Amendments To The Drawings:

This Amendment is in response to the Office Action dated **June 15, 2006**.

Fig. 1

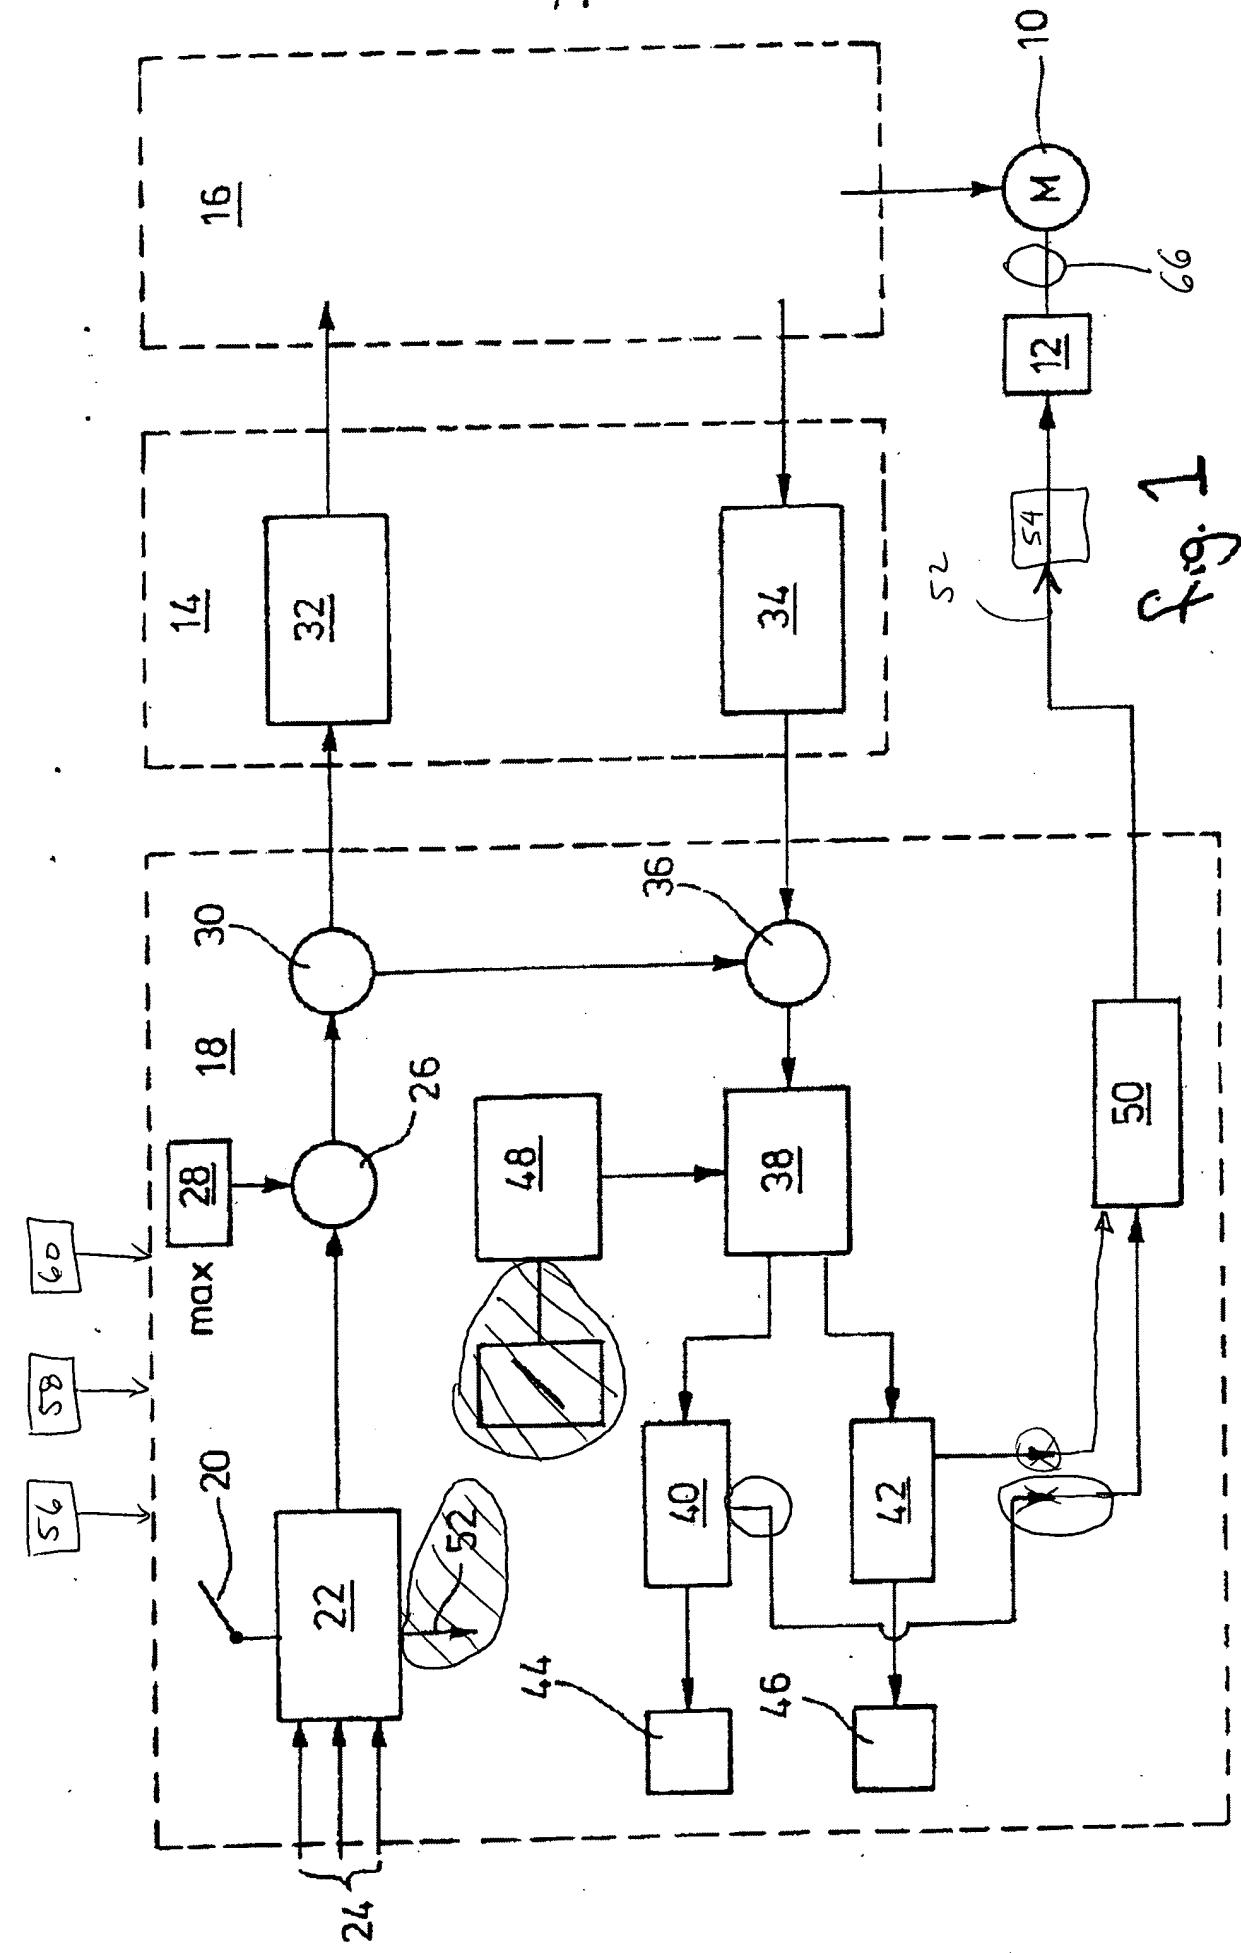
Applicants have included a Replacement Sheet and an Annotated Sheet with mark-ups. The attached sheet of drawings includes changes to originally filed Fig. 1. This sheet, which includes Fig. 1, replaces the original sheet including Fig. 1. Elements 56, 58, and 60 were included as inputs to braking control device 18, as described in the specification. The box to the left of element 48 was deleted. The output 52 at the bottom of box 22 was deleted. An arrow now connects box 40 to box 50, and box 42 to box 50. An arrow 52 is now shown outputted from box 50, and element 54 was placed in the line between box 50 and box 12. Finally, drive wheel 66 is shown between brake 12 and driving motor 10, as previously presented.

1. Figure 1 was objected to for various reasons. Applicants have submitted as an attachment a Replacement Sheet for Fig. 1 with the changes requested by the Examiner.
2. Applicants have also submitted as an attachment an Annotated Sheet showing the changes made to Fig. 1 as requested.
